UNITED STATES PATENT AND TRADEMARK OFFICE

Office Action Summary

09/982,584

SEGGERN, JORN VON

Part of Fig. 4 of Greenwell '887

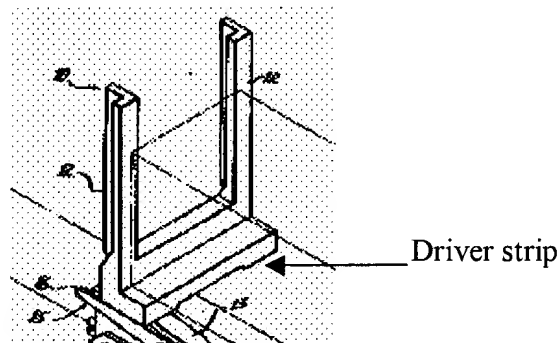
Greenwell discloses all of the claim limitations in a similar conveyor apparatus for transporting objects shown in fig. 4, the apparatus comprising a plurality of continuously circulating guided conveyor lines (20, 20a) with drivers (10,11) arranged at intervals from each

other wherein the conveyor line is constructed of continuously circulating individual chains (20) each of which has respective drivers (10, 11) arranged at intervals from each other, the intervals between the drivers of different individual chains may be adjusted (C4/L20-26) simultaneously. Greenwell further discloses that the drivers (10, 11) are held on each conveyor line (20, 20a) so that they can be adjusted in the direction of transport (C4/L23-26) and that the drivers (10, 11) connected to each conveyor line (20, 20a) are located at fixed intervals from each other (C4/L41-63).

Greenwell additionally discloses that each driver has driver strips (fig. 4) that extend across all of the conveyor lines transversely to the direction of transport.
